AUSTRALIAN WAR MEMORIAL

Eastern Precinct Development and National Service Memorial

**SUPPLEMENTARY SUBMISSION TO THE PARLIAMENTARY
STANDING COMMITTEE ON PUBLIC WORKS**

October 2008

Proposed Site Plan

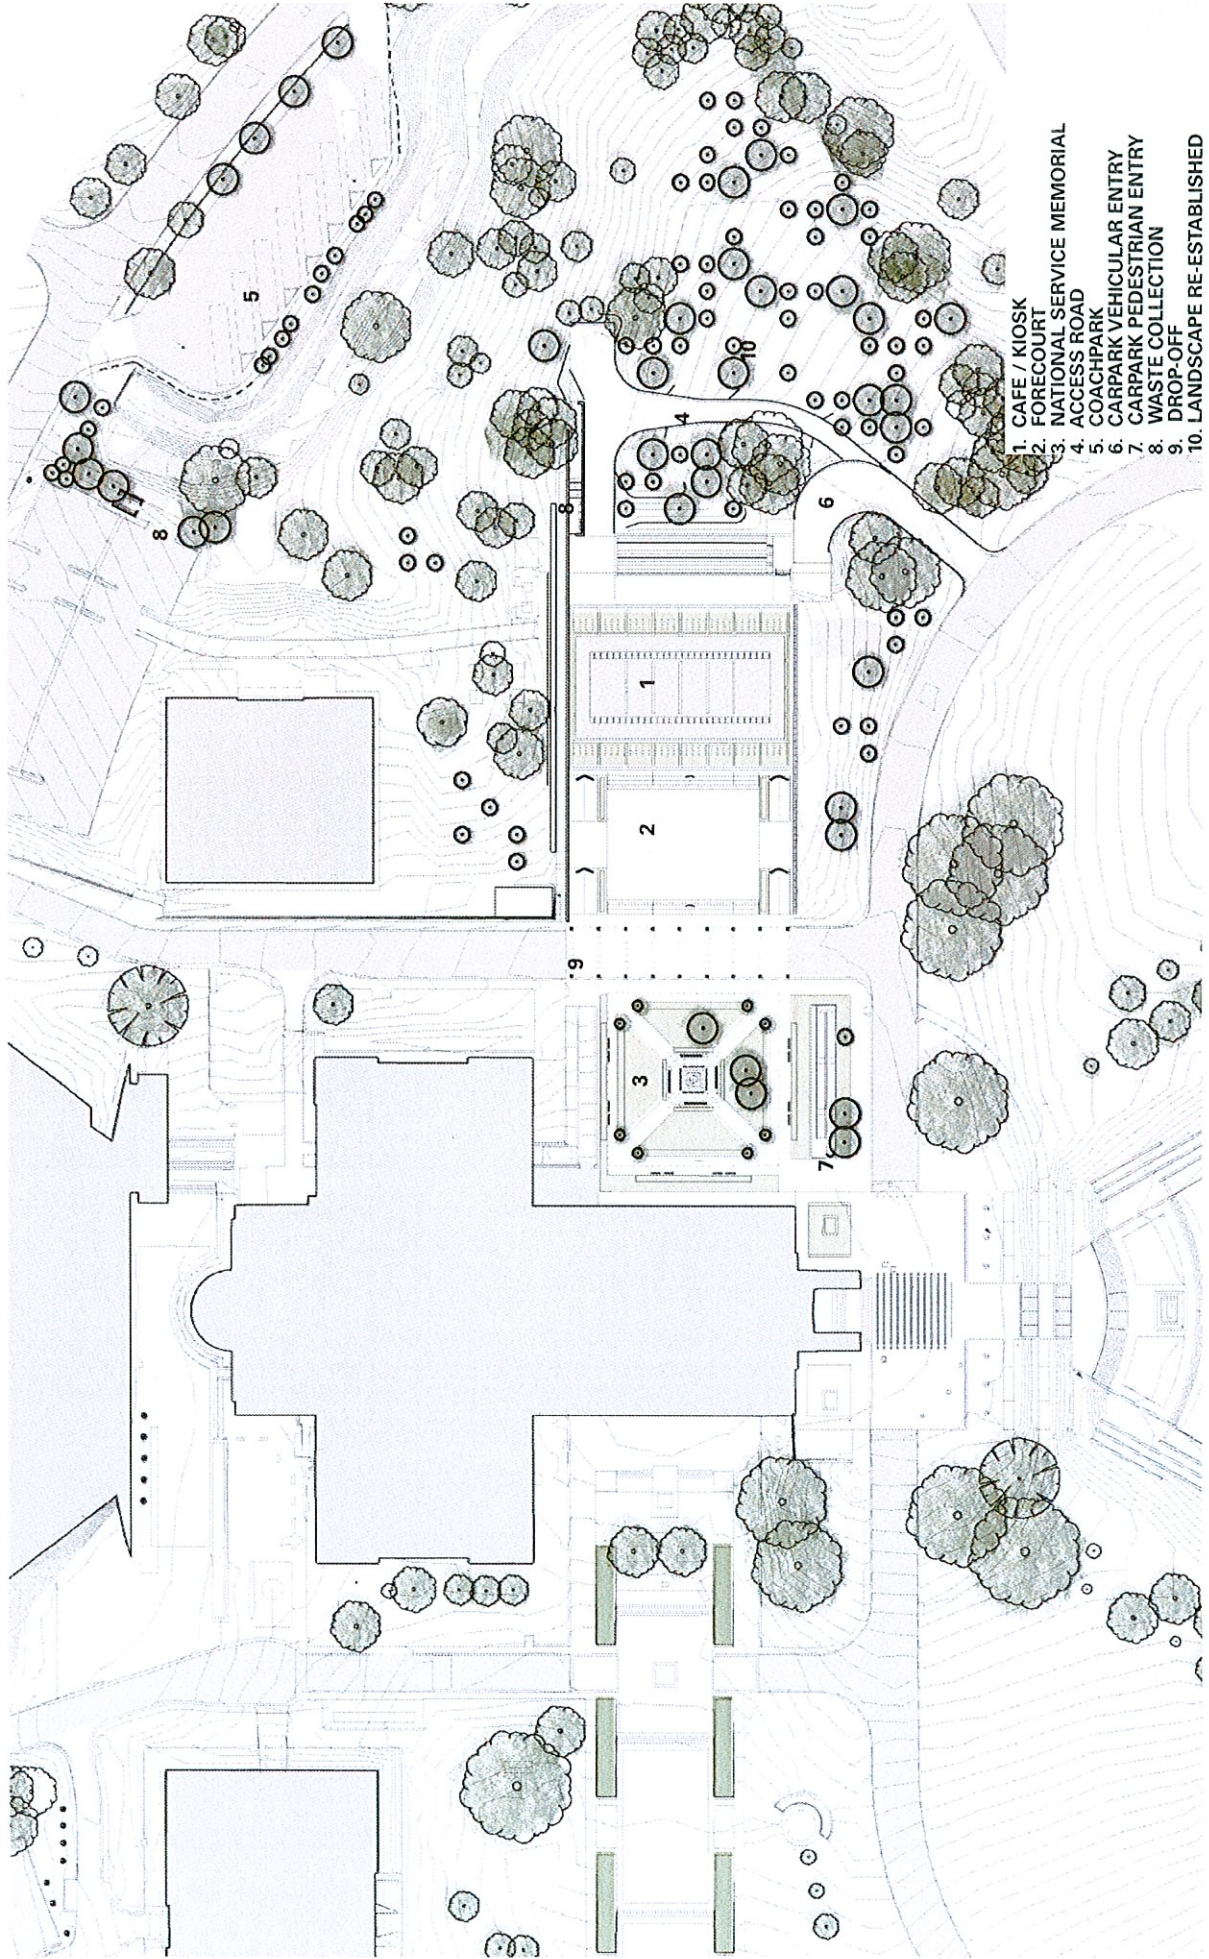
20 **Coach parking** – After liaison and consultation with the project traffic consultants, the architect, local residents, coach drivers and school representatives the coach parking concept design has been refined. To safely accommodate loading and unloading passengers, improve sighting and screening in the landscape (and maintain ‘wildlife corridors’ to the site), and reduce expenditure by removal of the need to cover the existing open stormwater channel, the size of the coach park has been reduced to eight vehicles. The vehicle egress and parking alignment has also been refined. The size reduction (and new alignment) still provides increased capacity on the existing and meets the demand for coach parking space.

The service road from the coach park has been deleted. The service arrangement for the new café has been relocated to the south to be less intrusive in the landscape. The garbage enclosure in the north of the site (servicing the CEW Bean and ANZAC Hall buildings) will remain but be discretely located next to the existing CEW Bean building car park.

- Proposed Site Plan (revised – new arrangement for access road and vehicle entry)
- Basement Plan (revised – new arrangement for vehicle entry)
- Ground Floor Plan (revised – new arrangement for vehicle entry)
- Roof Plan (revised – new arrangement for vehicle entry)
- Elevations (revised – new arrangement for vehicle entry)

Basement Plan

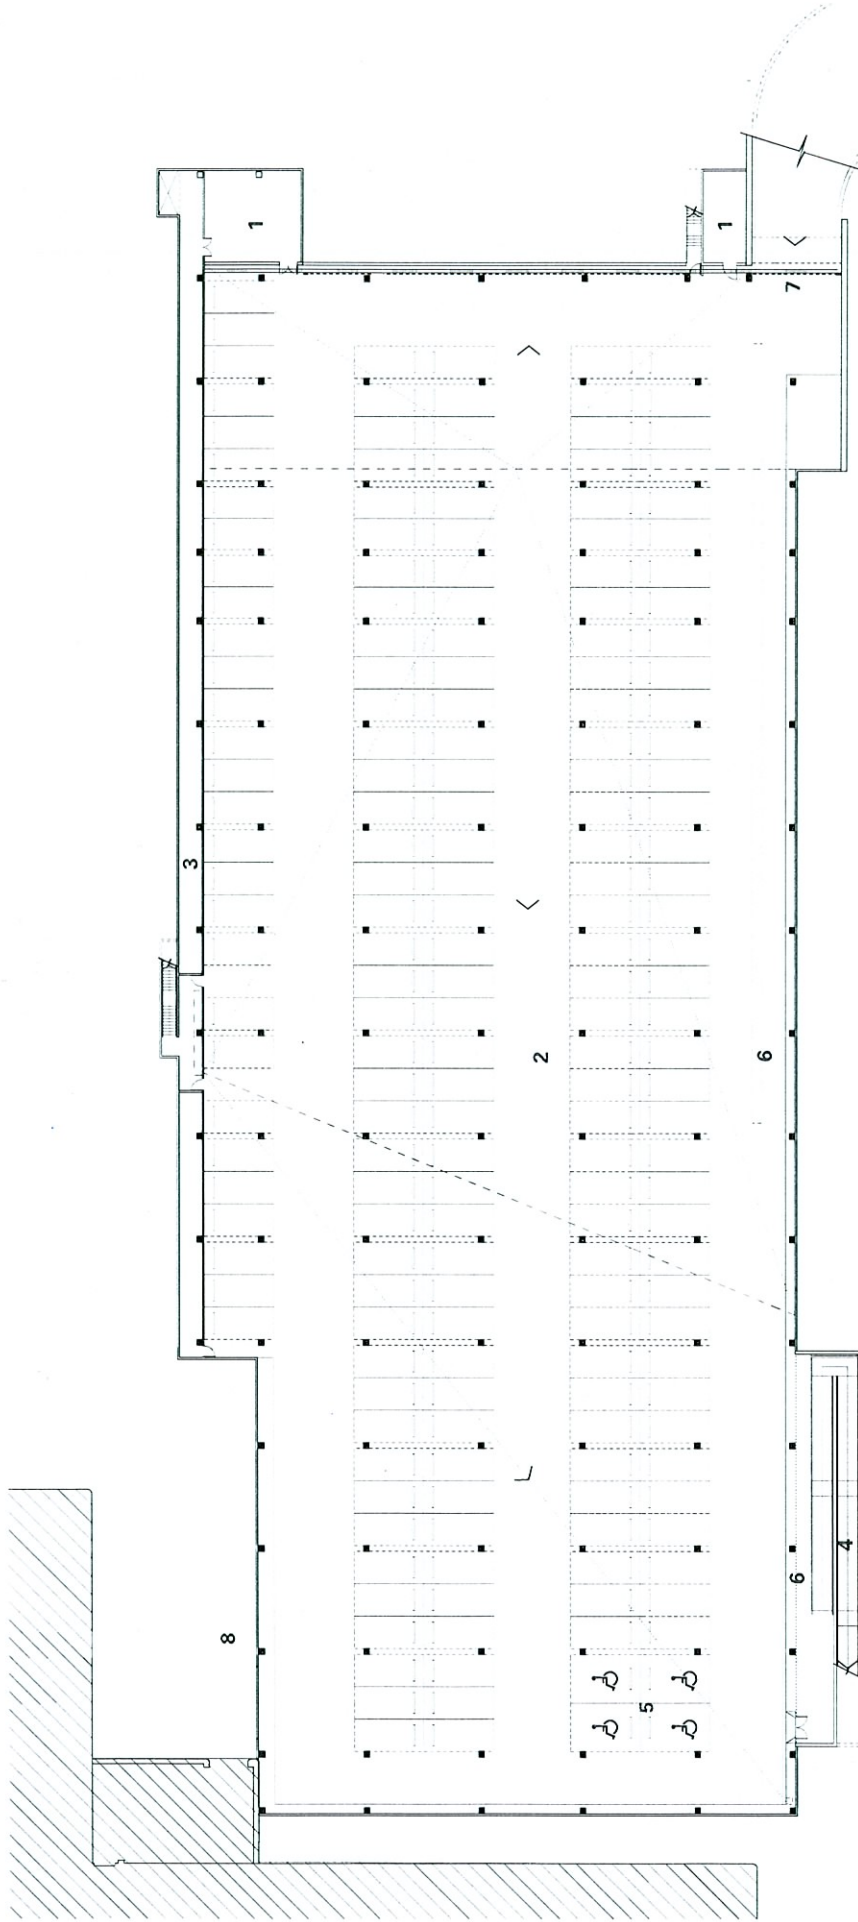
19 **Underground car parking** – The current car park design concept allows space for 191 cars including four accessible car parking spaces. This size allows further retention of established trees on the eastern edge of the car park footprint. Access to the underground car park is still from the east access road off Fairbairn Avenue however the access has been shifted further east and enters the underground car park from the eastern side. This design change responds to heritage and aesthetic concerns raised in regard to the car park entry prominence in the main vista. The design change also allows egress to service deliveries and less intrusive café rubbish collection and storage arrangements. The significant and intrusive road infrastructure to service the café, previously shown in the north of the precinct, has been deleted.
